NEW MEXICO ENERGY, MINERALS and NATURAL RESOURCES DEPARTMENT

Re: Injection Pressure Increase

Stella Needs A Com Well No. 1E SWD

Re: Step Rate Test - Stella Needs A Com No. 1E SWD

Stella Nees A Com No. 1E SWD - Step Rate Test Data 4/2/2002

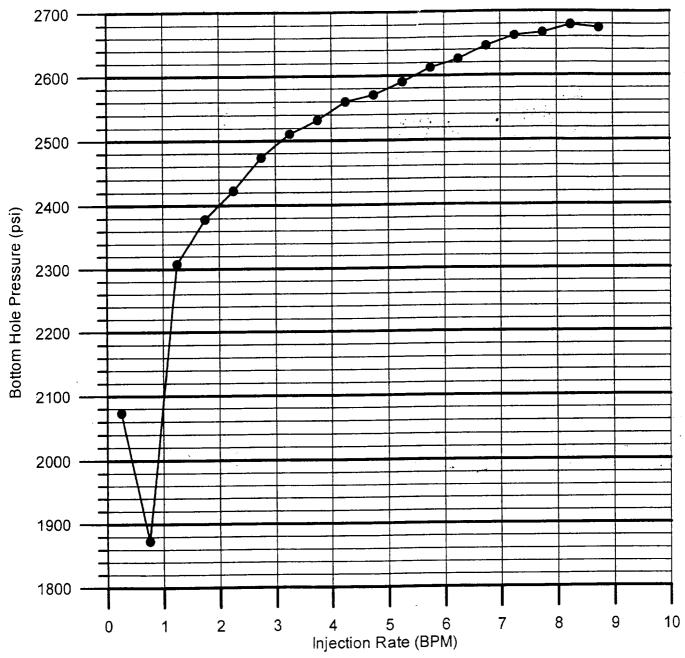
I request that you approve an increase in the injection pressure allowed at the subject well to the maximum pressure reached during the subject step-rate-test. Attached is the data collected from that test. The data is in graphical, tabular, and disk (in an Excel spreadsheet) formats. My interpretation of the data indicates parting pressure was not reached. I was forced to terminate the test because of surface pressure exceeding the safe limits of the wellhead connections. Please call if you have questions.

- The Point Lookout member of the Mesaverde is a massive sandstone, which I would not expect to part easily until much higher rates are established.
- The bottom hole pressure recorder was set at 3,622'.
- The water injected into this well has a specific gravity of 1.02. This calculates to be a hydrostatic column of 0.4417 psi/ft. Water used during the test was the same as that injected during normal injection operations.
- The surface shut-in pressure after conducting the step-rate-test was 1,100 psi.

The last point of the test may indicate a break, but I was experiencing surface problems which cause me to doubt the lepander DUFANC CPTNET. COM accuracy of this point.

Reference is made to your request dated April 16, 2002 (received in this office April 18, 2002), to increase the surface injection pressure on the above referenced SWD well. This request is based on a step rate test conducted on the well on April 2, 2002. After reviewing test results, we feel an increase in injection pressure is justified at this time.

This well is equipped with 2 7/8" coated tubing and injection packer. With size and type of tubing remaining the same, you are authorized to increase the surface injection pressure to the following:

Well and Location	Maximum Surface Injection Pressure
Stella Needs A Com Well No. 1E SWD (API: 30-045-24265)	1562 PSIG Water
1790 FNL, 790 FWL, Sec 36, T30N, R14W, NMPM, San Juan County
